Service Bulletin

TECHNICAL

Subject: Driver and/or Passenger Power Seat Height Stuck in the Full-up Position, Intermittent Inoperative Seat Adjustment or Not Lowering

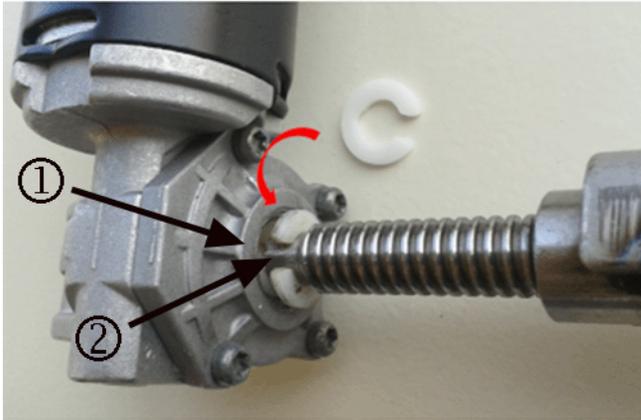
Involved Region or Country	North America and all N.A. Export Regions
Condition	Some customers may comment on the front power seat height adjustment (not the tilt function) being inoperative, not lowering or being stuck in the uppermost travel position. They may also comment that the up/down function works intermittently.
Cause	The cause of this condition may be manufacturing variation of the height adjuster motor casting interface to the spindle nut, while in the uppermost position.
Additional Options	Equipped with Power Adjustable Seats (RPO AG1, AG2, AMM, AKQ, ADS, AE8 or AH8)

To eliminate the manufacturing variation, add a split washer/retainer to the drive screw between the interface of the motor casting (1) to the spindle nut (2). The graphic above shows the height adjuster motor with the retainer added, and another sample retainer alongside the motor.

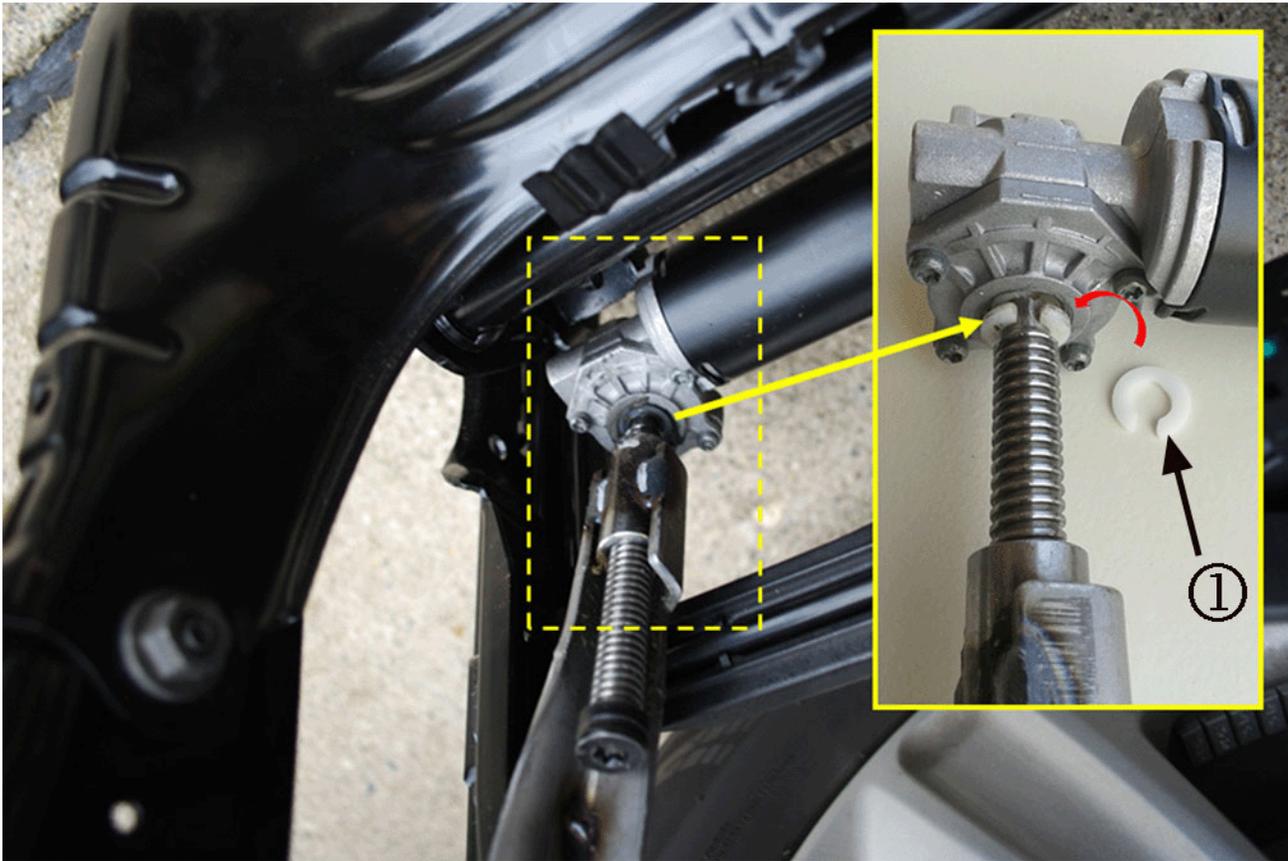
Note: Depending on vehicle model, the retainer can be installed from the front or the rear, however in most cases it may be easier to visually see the install location from the rear.

3. Reaching under the seat, install the retainer (1) to the motor drive screw.
4. Once the retainer is installed, it may be necessary to press the button 3 to 4 times to ensure the washer is properly seated.
